# Dalrymple Bay Coal Terminal User Group

Declaration review regarding Dalrymple Bay Coal Terminal

Submission in response to:

- 1) submission provided by DBCT Management dated 30 May 2018
- 2) addendum to that submission provided by DBCT Management dated 18 June 2018
- 3) QCA Staff Questions dated 6 June 2018

**Figure 5: HoustonKemp Criterion (b) Report Figure 2.10 – With Errors Highlighted**

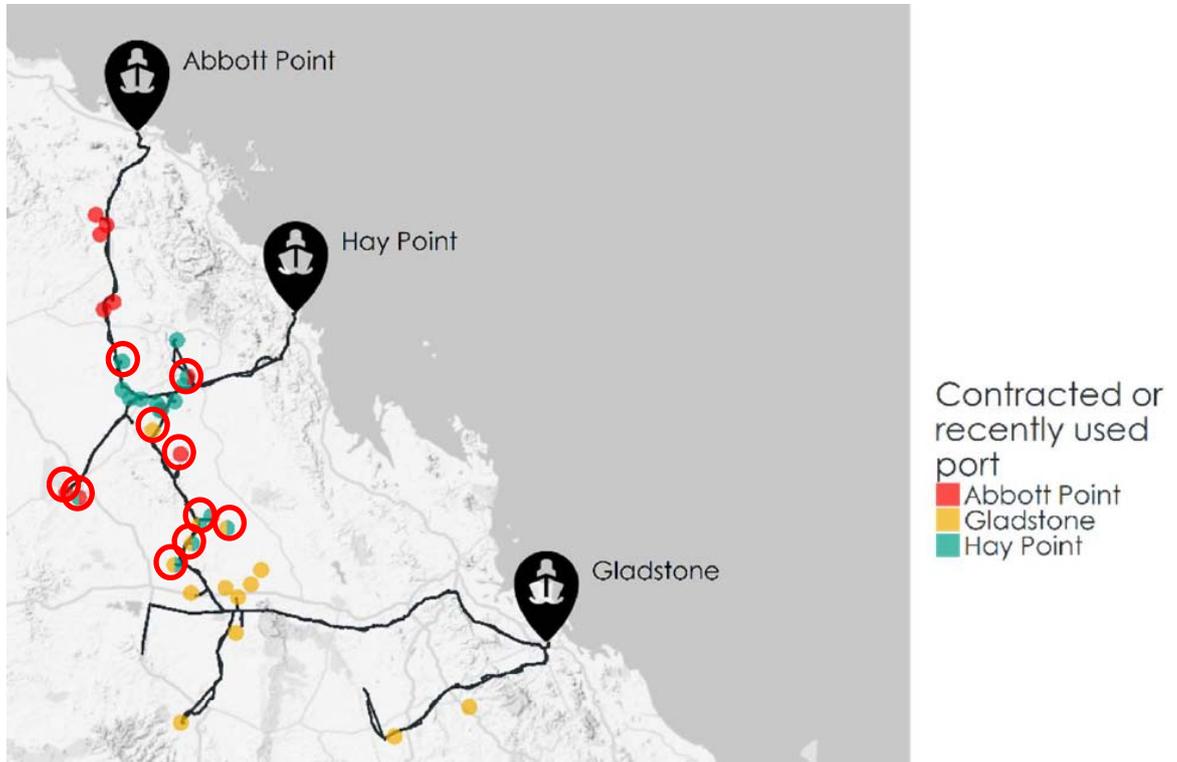
- (a) the errors in the map - such as the fact that the South Walker Creek mine does not use APCT as incorrectly suggested in the original version of this map in the HoustonKemp Criterion (b) Report. As described in more detail later in this submission, BMC has confirmed that South Walker Creek has never exported tonnage through APCT for reasons including the need for an expensive 'western rail turnout' to be developed to facilitate that occurring. The DBCT User Group can only presume that DBCTM/HoustonKemp have erroneously assumed APCT usage because DBCTM has incorrectly assumed BMC's APCT contract is used for South Walker Creek); and

In particular, the arguments in the HoustonKemp report are largely based around the following diagram (Figure 2.10) which is asserted to show the projects which are utilising coal terminals at the three major ports.

- (e) Capcoal: Anglo American confirms that in respect of Capcoal (which is shown as partly using DBCT and partly using Gladstone capacity) only a very small proportion of Capcoal production is exported through RGT – and that occurs in order to enable Anglo American to meet particular customer requirements, not as a result of switching to RGT in response to price rises of the Declared Service;

Once those errors are fixed, that results in the following far more accurate representation:

**Figure 2: Reproduction of Houston Kemp's Figure 2.10**

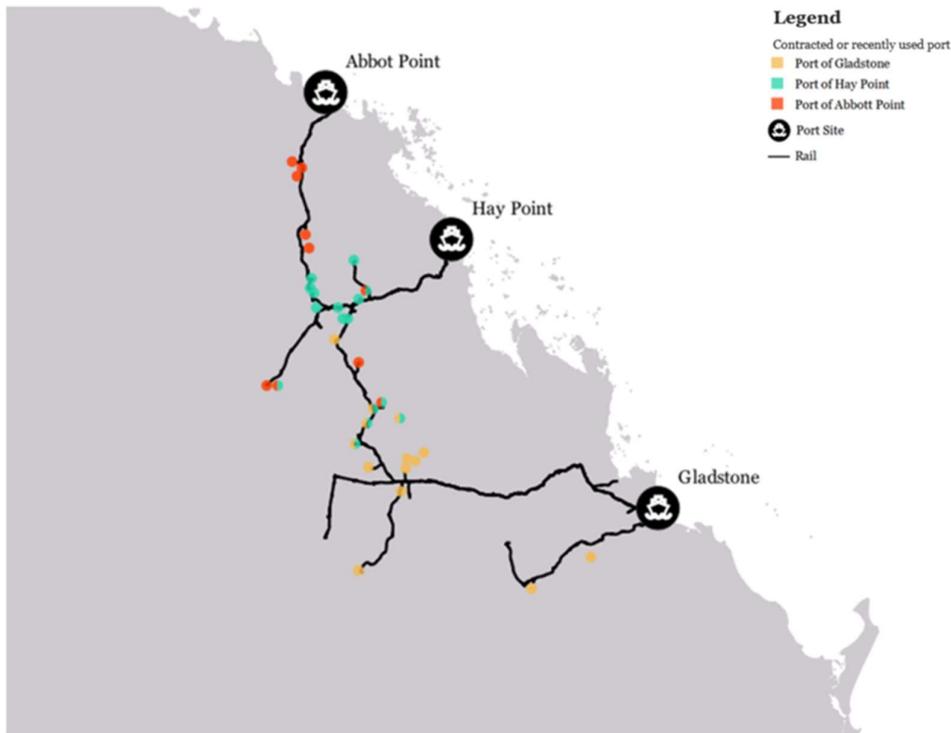
Supporting this conclusion, Houston Kemp includes in its report an illustration of the apparent extent to which the 'market' for coal handling services is defined by interconnectivity and substitutability between Hay Point and coal export ports to the north and south. In its Figure 2.10,<sup>14</sup> Houston Kemp show that there are mines which appear to ship through coal terminals contrary to an expected preference for the closest proximate port (and therefore shortest rail haulage distance). We reproduce Houston Kemp's Figure 2.10, below.

**Figure 3: Reproduction of Houston Kemp's Figure 2.10, with errors corrected**

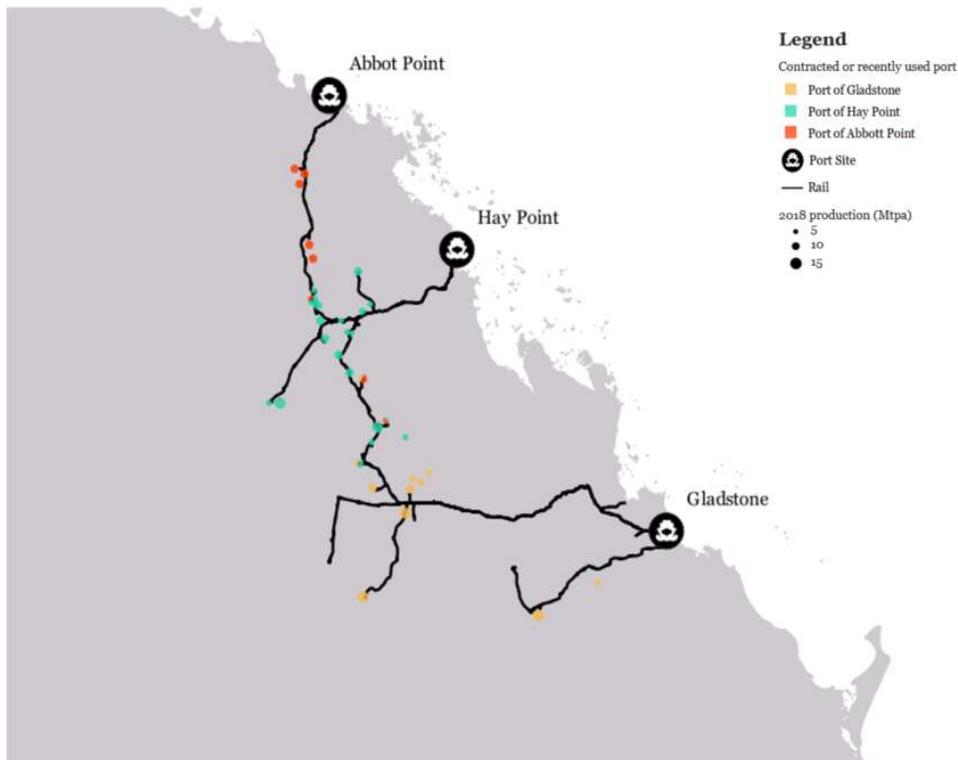
Correcting for these factors, the boundaries of the market become clearer. In Figure 3 we present the same illustration, but adjusting for actual utilisation by each of the respective mines. What is clear from this corrected presentation is that there is a clear catchment of mines which ship through Hay Point, logically which reflects the significant rail haulage penalty associated with using more distant terminals. Some inevitable 'grey' areas remain, at the outer edges of this catchment, but this is uncontroversial and competition regulators frequently have acknowledged and accept that market definition boundaries rarely will be absolute and distinct.
